Shaping Streets Design Review

Strategic Site, Infinity Garden Village
STRA 1

1.2 A Design Review (DMDR047) was undertaken in January 2025 to consider the potential of the site. This comprised a multi-disciplinary panel which included urban design, social structures, architecture, sustainability, ecology / biodiversity net gain, chartered surveyor / regeneration, landscape and transport / active travel. The Panel's aim was to help maximise the value associated with the development through good design, and considering potential value holistically, in terms of environmental, societal and economic benefits.

STRA 1: Part of the Draft Derby Infinity Village, Mixed Use Allocation

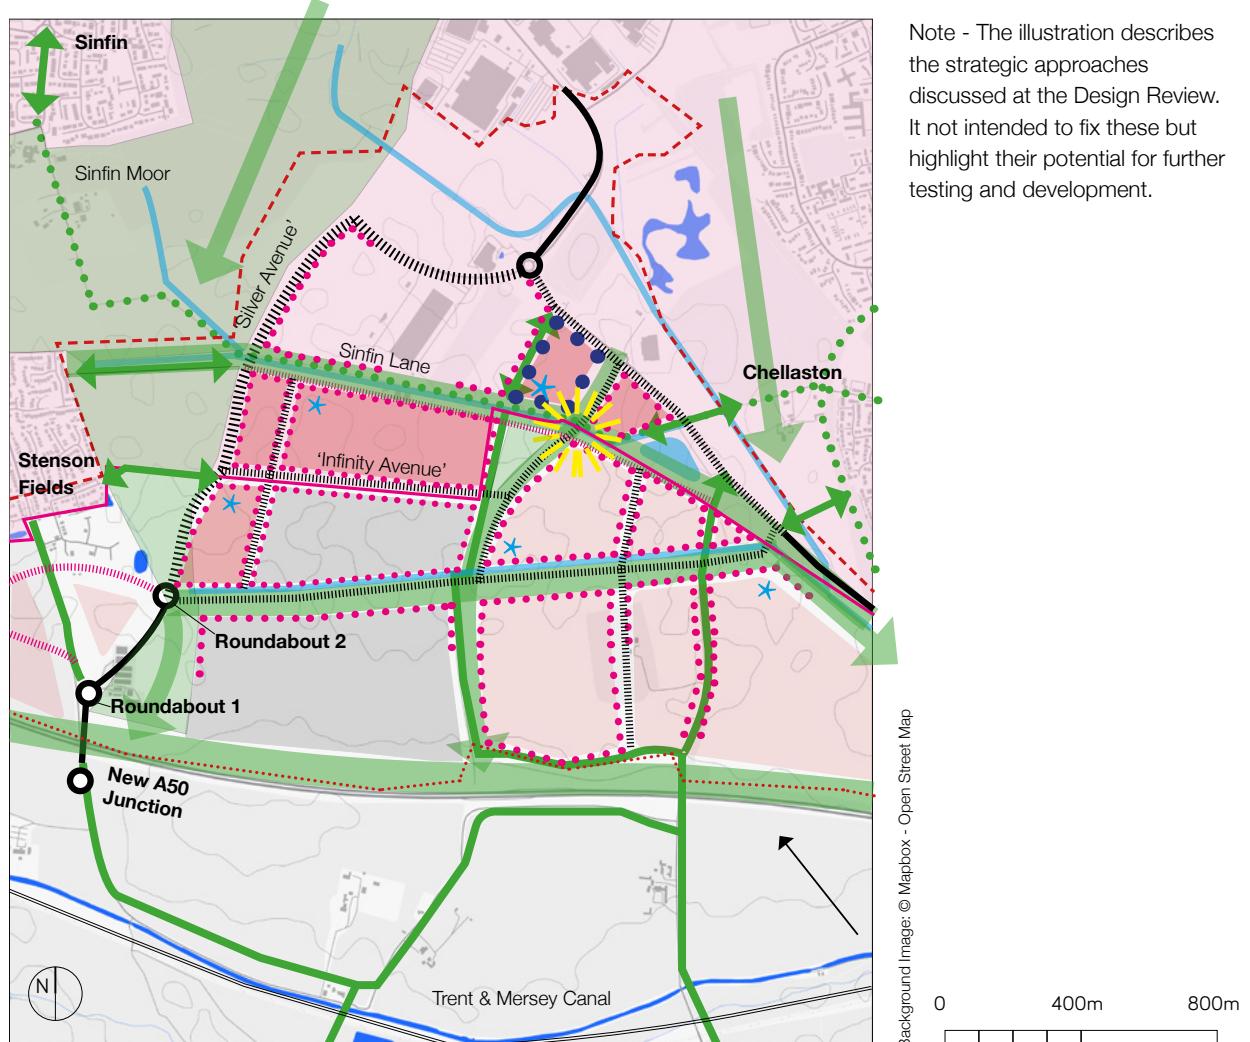
Illustration broadly locating site features discussed in the Design Review.
